# ARRON/BIJOU INTERCHANGE

FIR SUBMITTAL - AUGUST 2003

# **Cimarron/Bijou design memorandum**

**Subject: Alignment Design Memo**

*Widen Bijou Structure (East bound)*

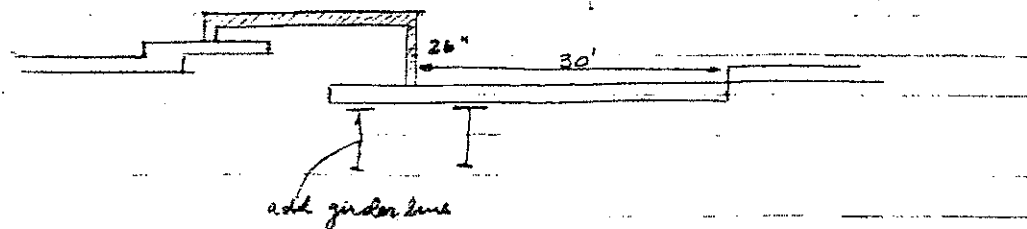
EVALUATION	
Idea Number: 02-005	
Idea Description: Widen and rehabilitate the existing bridges on Bijou Street over Monument Creek and the railroad.	
Advantages:	
<ol style="list-style-type: none"> <li>1. Reduced construction cost.</li> <li>2. Simplified construction</li> <li>3. Reduced construction in Monument Park</li> <li>4. Reduced construction impacts to traffic.</li> </ol>	
Disadvantages:	
<ol style="list-style-type: none"> <li>1. Reduced cross section width</li> <li>2. Substandard clearance over railroad.</li> </ol>	
Risks:	
<ol style="list-style-type: none"> <li>1. Existing bridges will have a shorter service life than new bridges.</li> </ol>	
Conclusion:	
<input checked="" type="checkbox"/> Propose this idea <input type="checkbox"/> Propose this idea as a Supplemental Recommendation <input type="checkbox"/> Do not propose this idea because

Remove slab		\$ 50,000
Remove sidewalk		50,000
Add 2 girder lines	$360 \#/\text{ft} \times 483 \times 2 \times 1.00 \#/\text{ft}$	350,000
Conc. deck	$\frac{3}{4} \times 483 \times 8' = \frac{2576 \text{ ft}^2}{27} \times 154 \text{ psf} \times 300 =$	28,520
	Remove $250 \#/\text{ft} \times \frac{2576 \text{ ft}^2}{27} \times 2.50$	12,000
Rehab. (upgrade Rail, street in general)		500,000
		\$ 990,500
		save \$ 990,000

<b>Response to Value Engineering Proposal</b>
<b>Project:</b>
<i>Proposal No.: P 02-005</i>
<i>Proposal Description: Widen and rehabilitate the existing bridges on Bijou Street over Monument Creek and the Railroad.</i>
<i>Recommended Action: Reject.</i>
<i>Discussion: Existing Bridge does not work with proposed horizontal and vertical geometry. CDOT may defer the construction of Bijou east of the east ramps until a later time (approx. \$10M in savings).</i>
<b>Construction Cost Savings Comparison</b> VE Team Savings Estimate \$ 7,800,000 Designer Savings Estimate Reason for Difference in Estimates
<b>Estimated Design Cost</b>
<b>Total Cost Savings (Designer Savings Cost Estimate - Estimated Design Cost)</b>

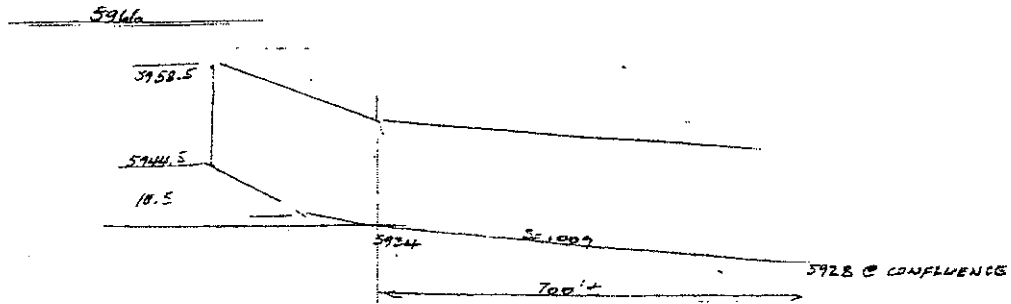
3. May require revision of FEMA mapping	
Risks:	
1. Potential danger for people to be drawn into the culvert	
2. May require some movement of the confluence of the two creeks although the confluence as it exists is not as precise as depicted on the plans for the project.	
Conclusion:	
<input checked="" type="checkbox"/> Propose this idea	
<input type="checkbox"/> Propose this idea as a Supplemental Recommendation	
<input type="checkbox"/> Do not propose this idea because

Between Sections EG & EF grade drops approx 3' in 300',  $s = 0.01$  or 1%

Assume a box depth of 14'; to provide roughly a 500' spacing  $500/14 = 36'$

<b>Response to Value Engineering Proposal</b>
<b>Project:</b>
<i>Proposal No.: P 01-048</i>
<i>Proposal Description: Use an improved culvert design for Fountain Creek in lieu of bridges at the Cimarron Street ramps and the main line.</i>
<i>Recommended Action: Reject.</i>
<i>Discussion: Not compatible with future pedestrian/recreational uses planned for the creek area.</i>
<b>Construction Cost Savings Comparison</b> VE Team Savings Estimate \$ 3,600,000 Designer Savings Estimate Reason for Difference in Estimates
<i>Estimated Design Cost</i>
<i>Total Cost Savings (Designer Savings Cost Estimate - Estimated Design Cost)</i>

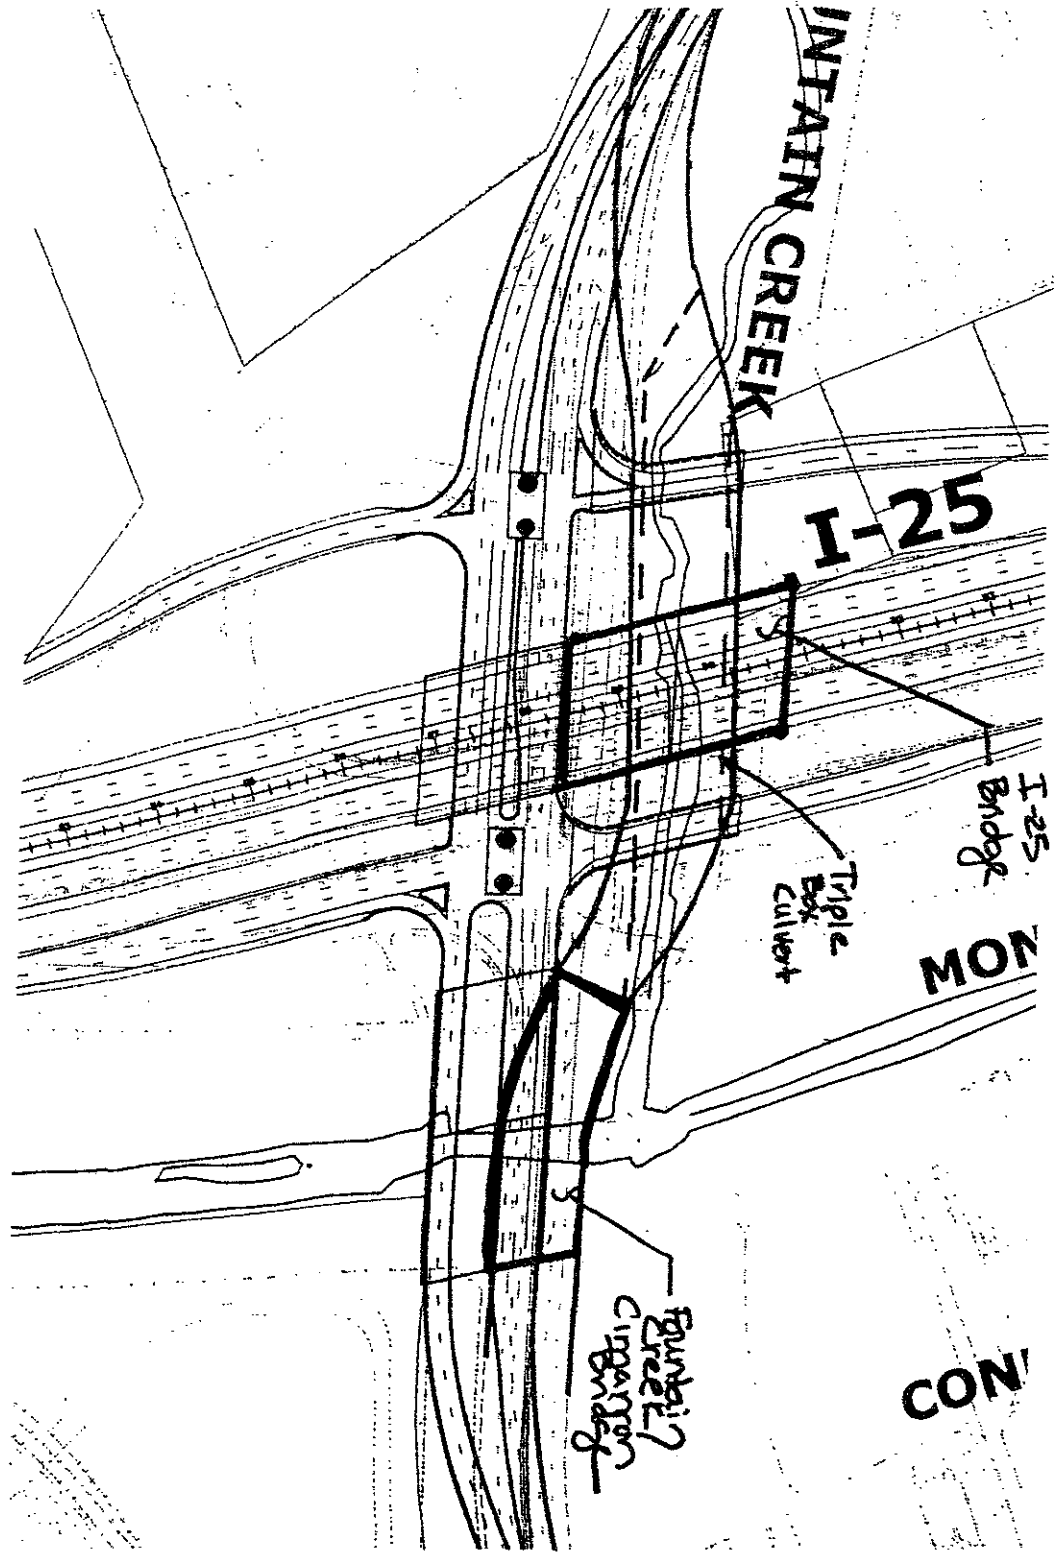
The construction phasing of the alternative will require shifting a reduced number of lanes on Cimarron to the westbound side prior to constructing the SB I-25 bridges. Construction of Fountain Creek bridge (under I-25) may have to be phased depending on what the existing structure configuration is.

This proposal is economical if a box culvert can be used for Fountain Creek.

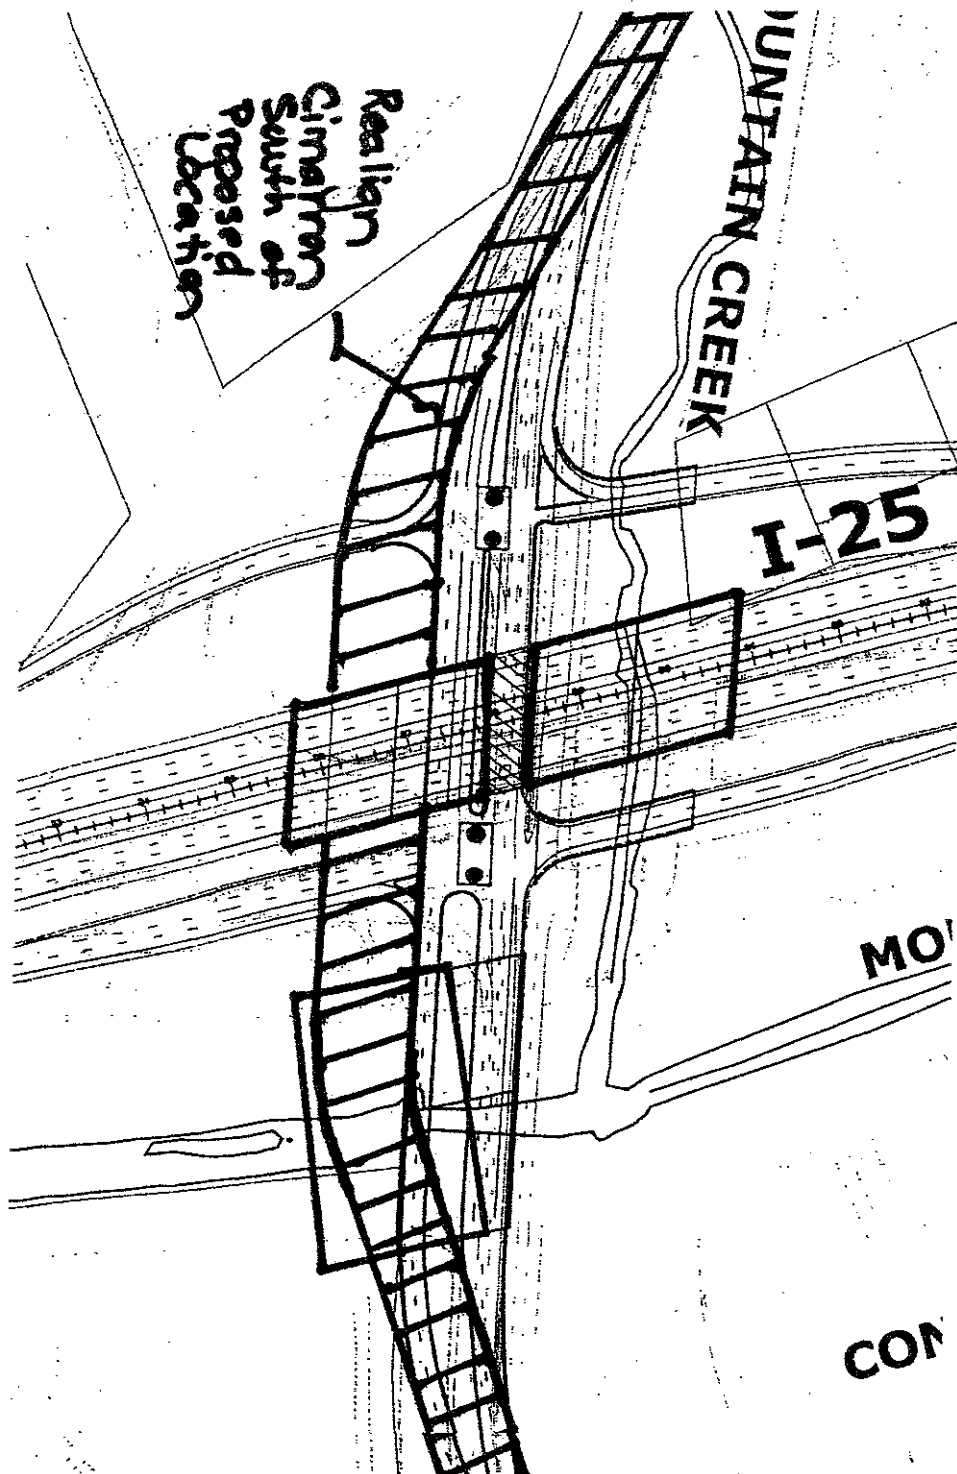
EVALUATION	
Idea Number: 01-053	
Idea Description: Build a fly-over structure from SB I-25 to EB Kiowa south of Monument Park	
Advantages:	
1. Eliminates the need for improvements to Bijou Street east of I-25	
2. Improves travel time of SB movements into downtown	
3. Eliminates 4f impacts at St. Marys Cathedral	
Disadvantages:	
1. Does not replace aging Bijou structure over RR tracks and Monument Creek	
2. Requires acquisition of Building to south of St Marys school and the Carnegie Library annex	
Risks:	
1. Public oposition to property impacts	
Conclusion:	
<input type="checkbox"/> Propose this idea	
<input type="checkbox"/> Propose this idea as a Supplemental Recommendation	
<input checked="" type="checkbox"/> Do not propose this idea because the property impacts are too high

1,400 lf fly-over structure over I-25 and railroad 1,400' x 28' (out to out) = 39,200 sf @ \$100/sf =	\$3,920,000
700 lf retaining wall along each side of SB off-ramp 700' x 2 = 1,400 lf @ 15' ht = 21,000 sf @ \$45/sf =	\$945,000
350 lf retaining wall along each side of east touchdown area 350 x 2 = 700 lf @ 15' ht = 10,500 sf @ \$45/sf =	\$472,000
2,000 sf of pavement at east touchdown 2,000 sf x \$35 =	\$70,000
75,000 sf ROW @ \$50 =	<u>\$3,750,000</u>
Total Infrastructure Cost =	\$9,157,000
Elimination of Bijou Street local road improvements:	<u>(\$8,198,000)</u>
Net cost of fly-over alternative =	\$959,000
PE, CE, and Contingency 35% =	<u>\$336,000</u>
Total Cost Savings =	\$1,295,000
